Addendum No. 2

Subject: Henry Lawton School Classroom Modernization Renovation
SDP Contract Nos. 2022-007-G, 2022-007-P, 2022-007-E

Location: Henry W. Lawton School
4501 Benner Street
Philadelphia, Pennsylvania 19135

This Addendum, dated 17 of February, 2022, shall modify and become part of the Contract Documents for the work of this project. Any items not mentioned herein, or affected by, shall be performed strictly in accordance with the original documents.

1 SPECIAL SYSTEMS PLAN - 1ST LEVEL - PARTIAL ZONE 'A'
 SCALE: 1/8" = 1'-0"
 E-130

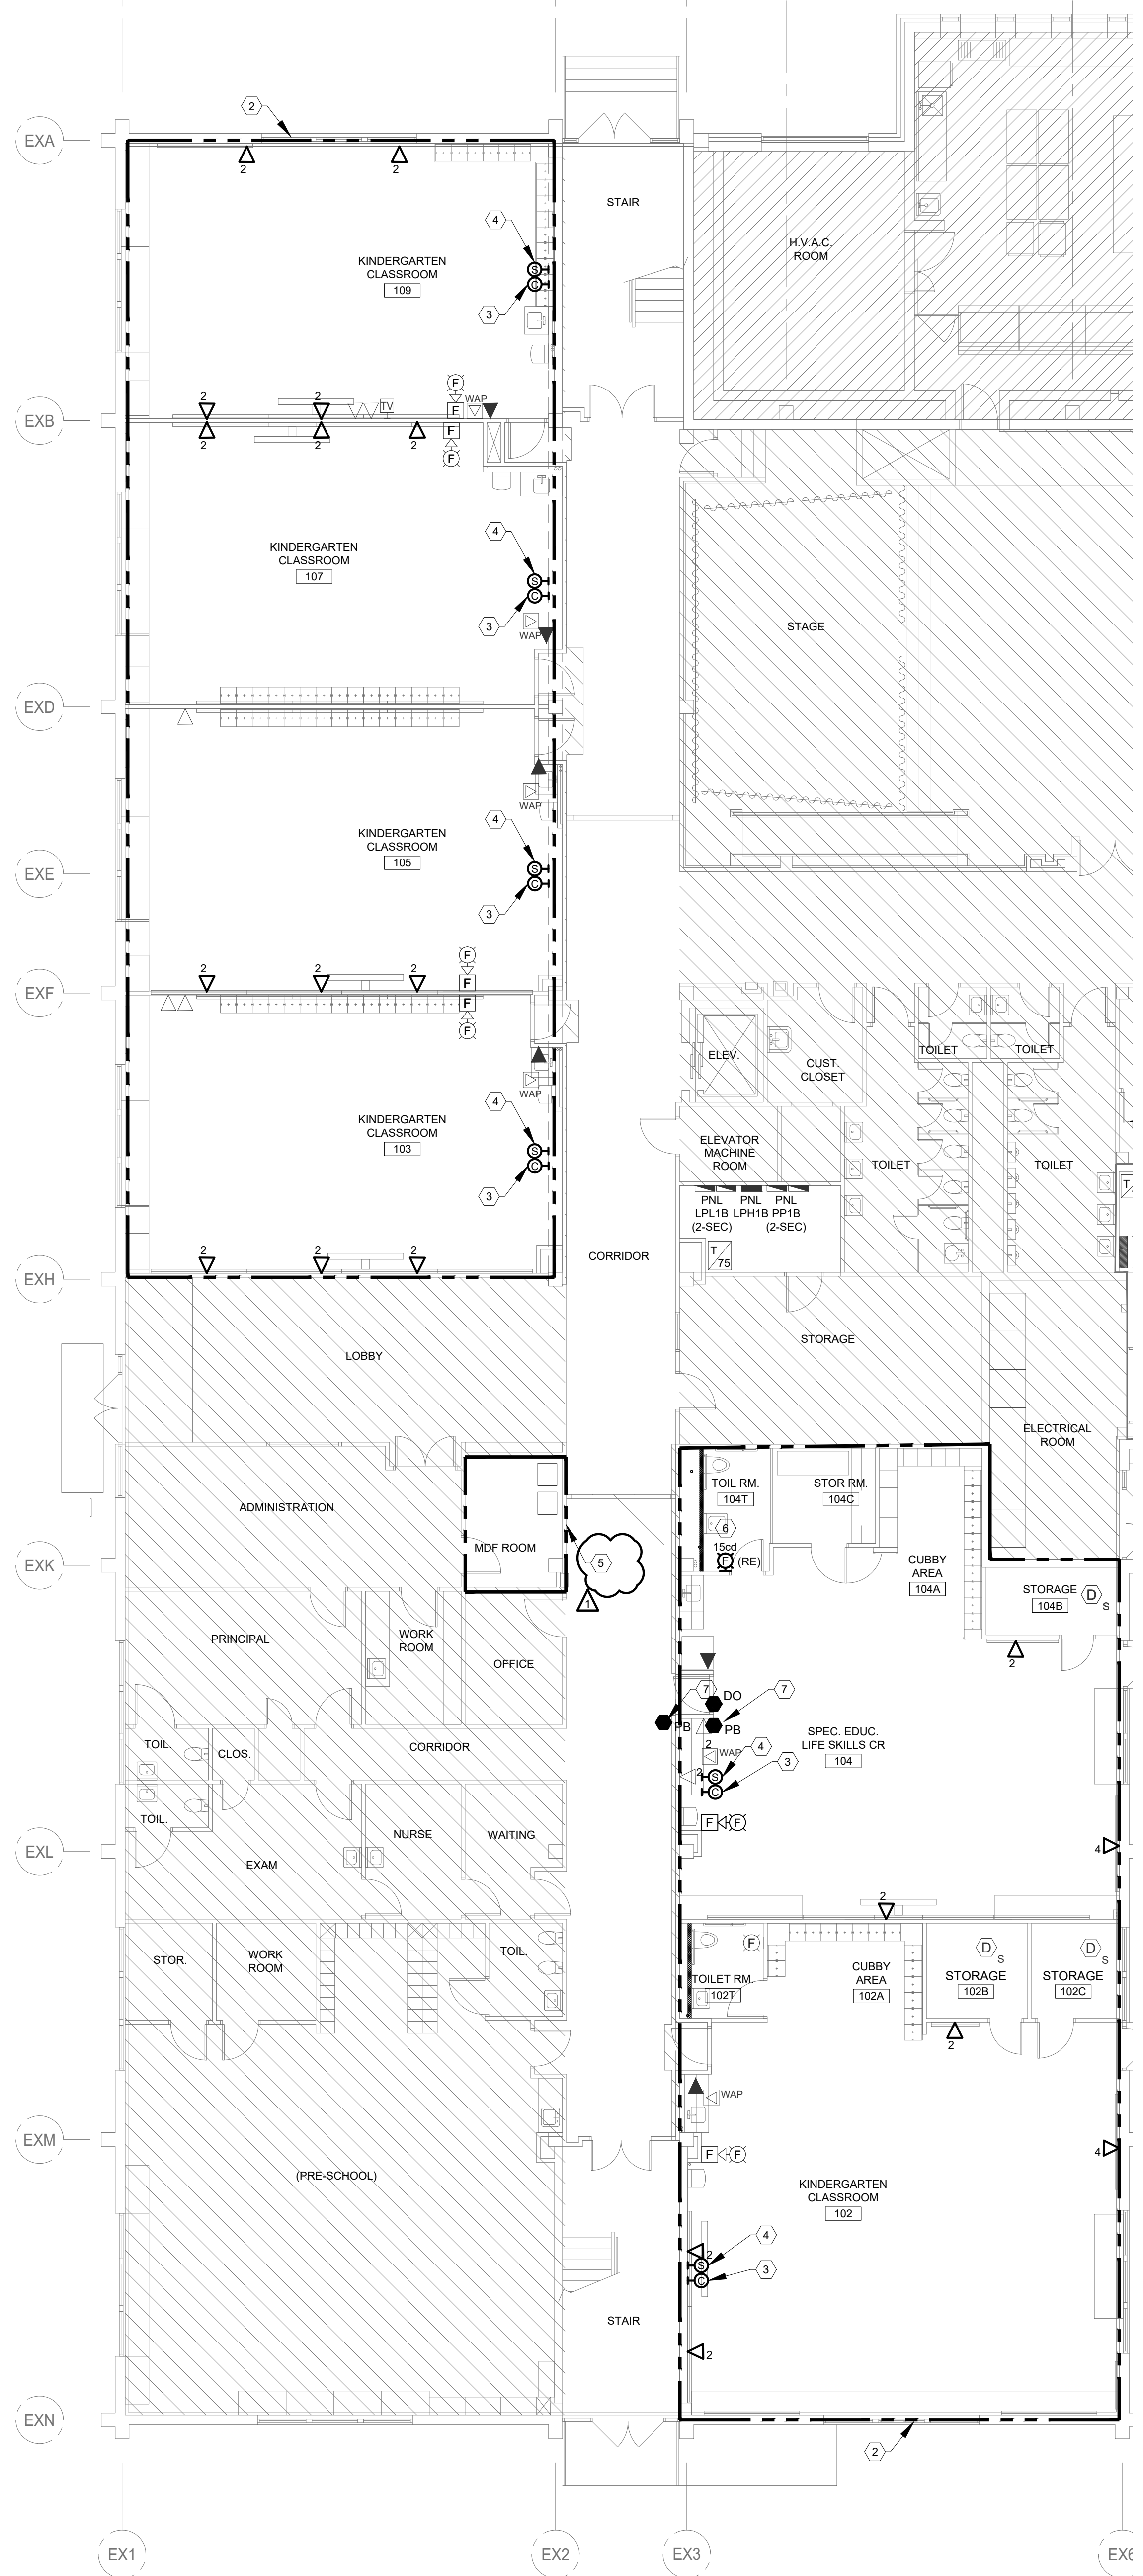
1. MODIFY General notes as indicated on drawings.
2. MODIFY Sheet notes as indicated on drawings.
3. MODFIY Detail 1 as indicated on drawings

Question 11: Drawings E-130, E-131, and E-132 show keynote #1 which mentions testing existing cables and removing/replacing the cables if they do not pass a test. The scope for removing/replacing the cables is **not** biddable. We cannot know what cables will pass and what cables will **not** pass prior to the bid, so it would be a complete guess as to how many won't pass. Please pick a scenario below to resolve this issue:

Question 12: Drawing E-130 keynote #5 and Drawing E-132 keynote #4 call for providing a new rack "as necessary". We cannot bid "as necessary" and SDP IT department should have coordinated this with the AE consultant during design phase. Please pick a scenario below to resolve this issue:

Question 14: Drawing E-130 keynote #4 specifies an analog speaker Bogen MB8TSQ. This keynote calls for a Cat6A cable which does not coordinate with the speaker specification. A Cat6A cable would be for a digital speaker but the specified speaker is an analog speaker that requires #16/2 twisted/shielded cable. Can SDP please clarify where to pick up the speaker circuit for this new speaker?

Answer 11: EC to replace all existing cables within scope of work area.

Answer 12: Provide new rack in the 1st floor MDF, wall mounted 2-post open frame rack (Tripp Lite #SRW08U22DP or approved equal). Mount new rack below the existing wall mounted IT rack in the room. New rack not required on 2nd floor, provide patch panels needed in existing racks.

Answer 14: All speakers shall require one CAT6 drop per speaker, each individually home run back to the MDF or nearest IDF. All speaker cabling shall be terminated on a patch panel at the closet, terminated on a RJ45 jack at the speaker, and shall be labeled at both ends according to the labeling guidelines in the specifications.

1 SPECIAL SYSTEMS PLAN - 2ND LEVEL - PARTIAL ZONE 'B'
E-132 SCALE: 1/8" = 1'-0"

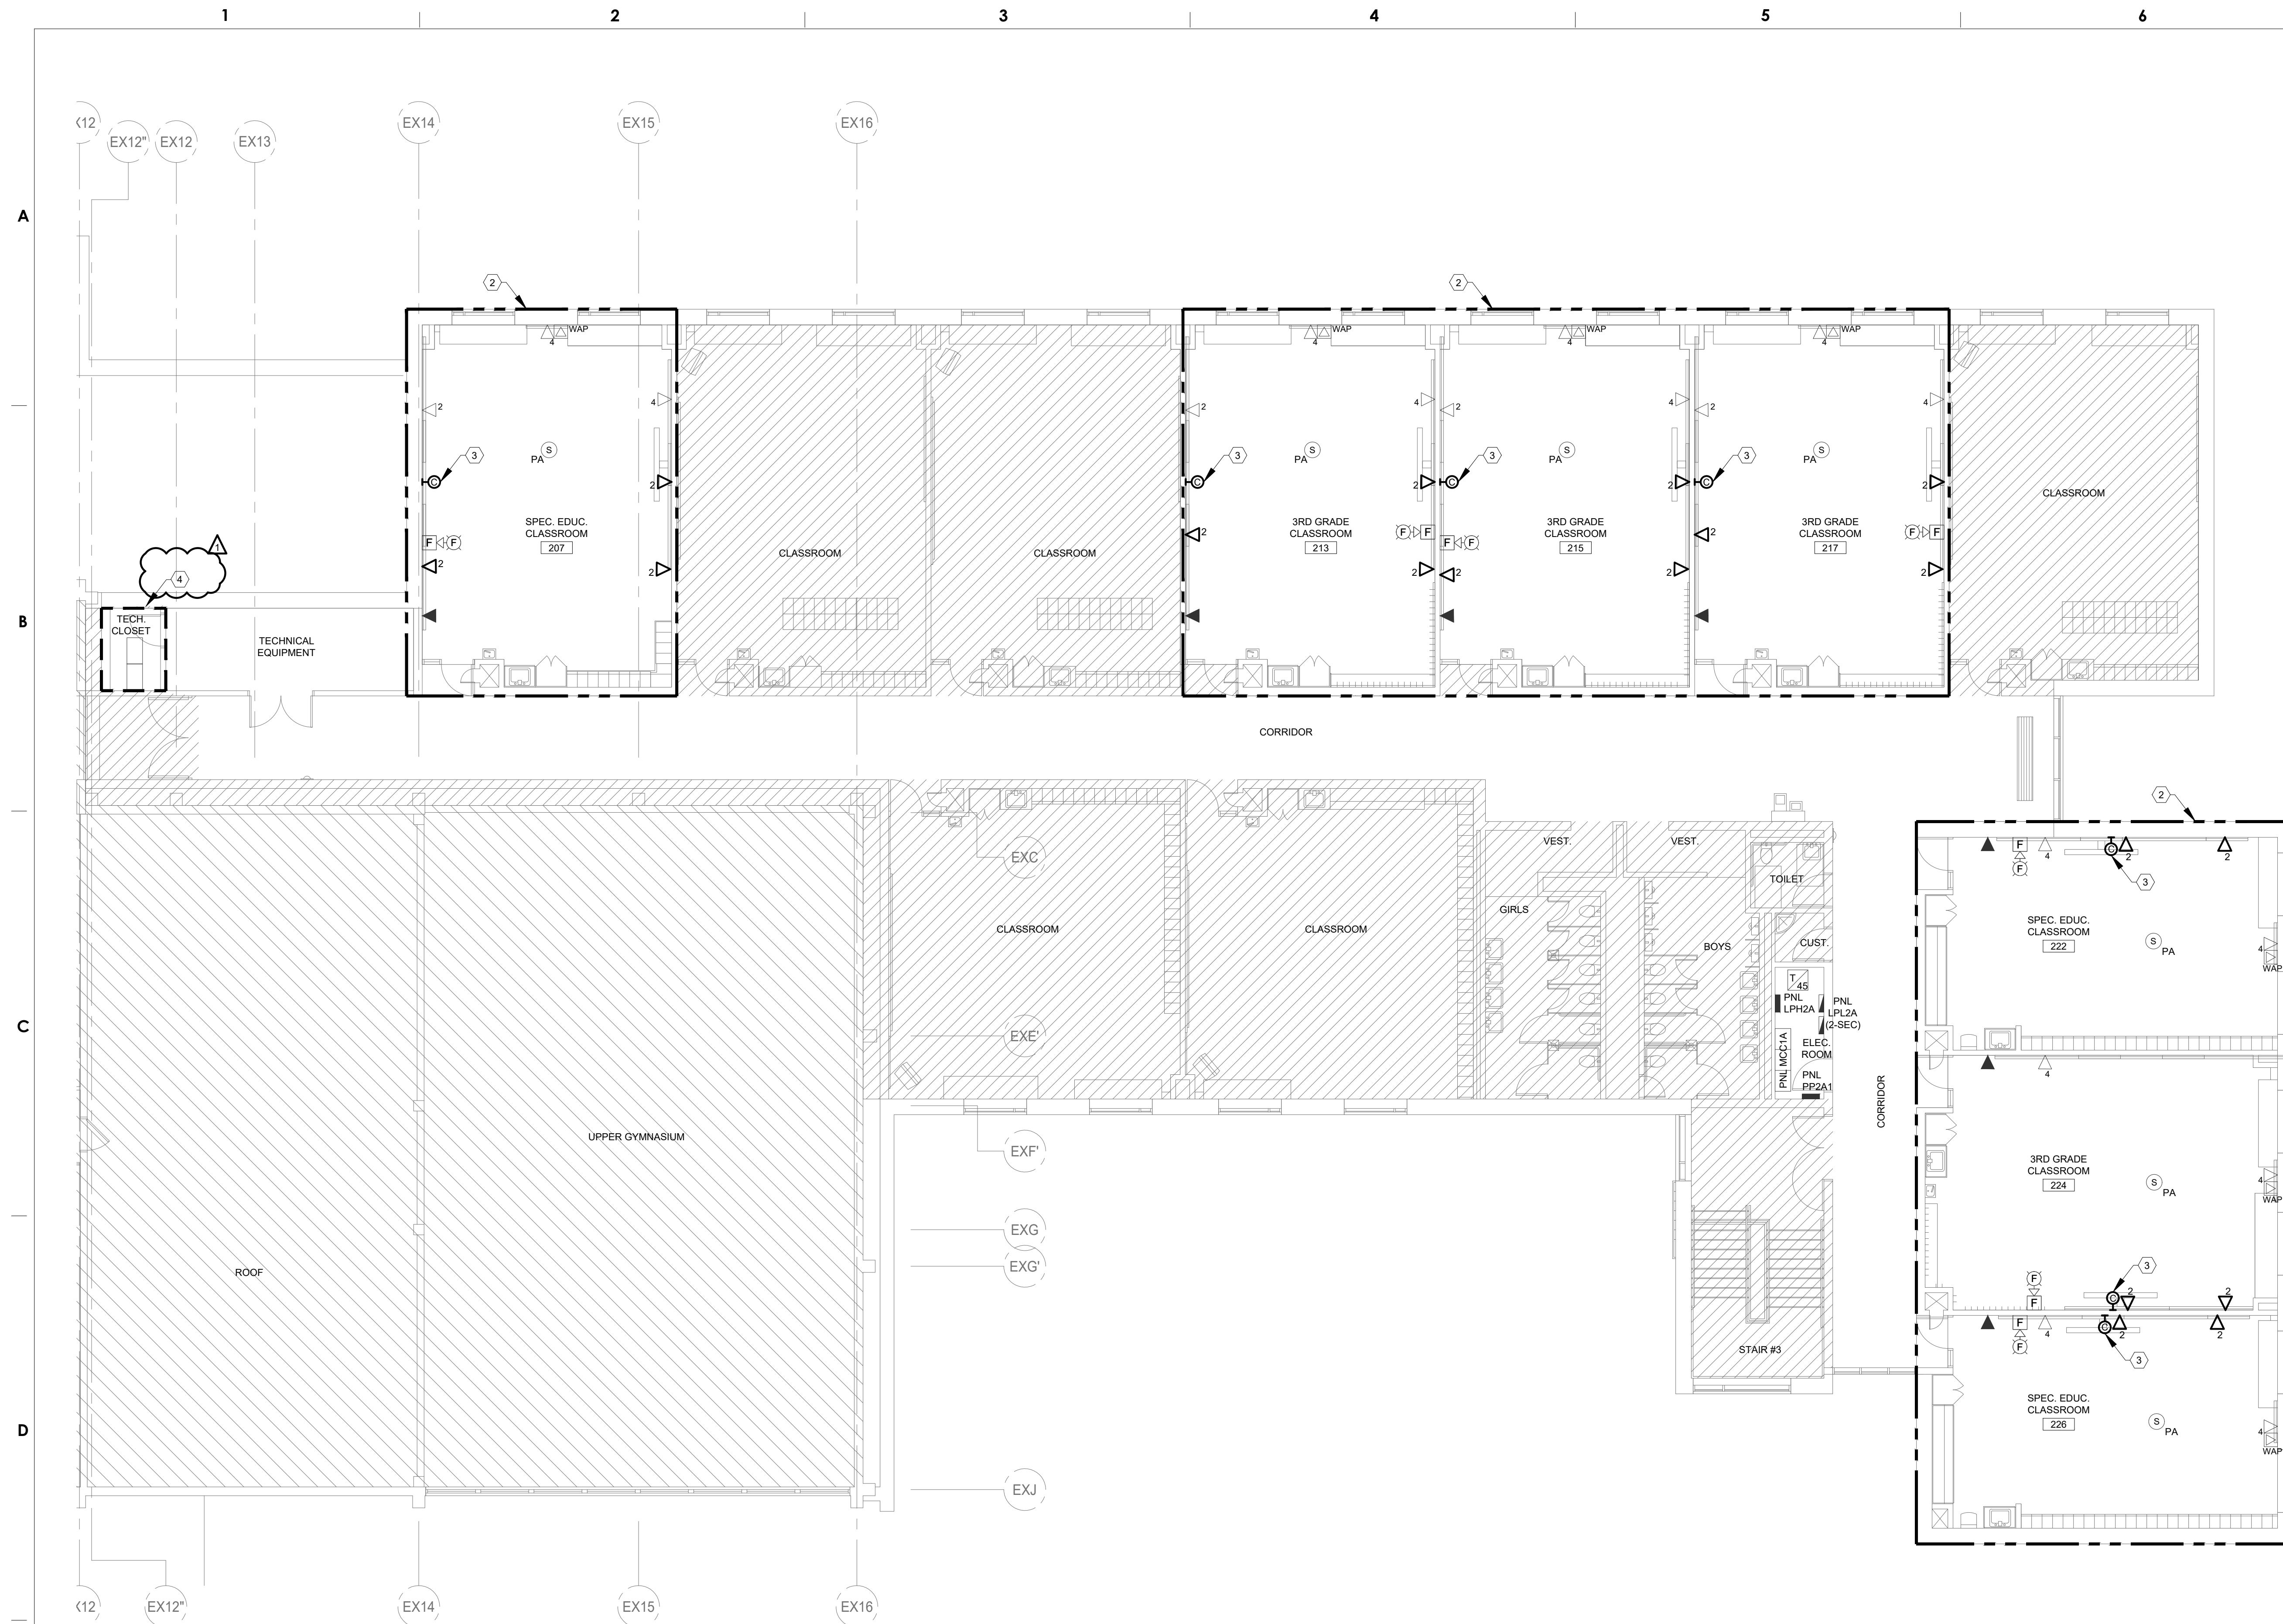
1. MODIFY General notes as indicated on drawings.
2. MODIFY Sheet notes as indicated on drawings.
3. MODFIY Detail 1 as indicated on drawings
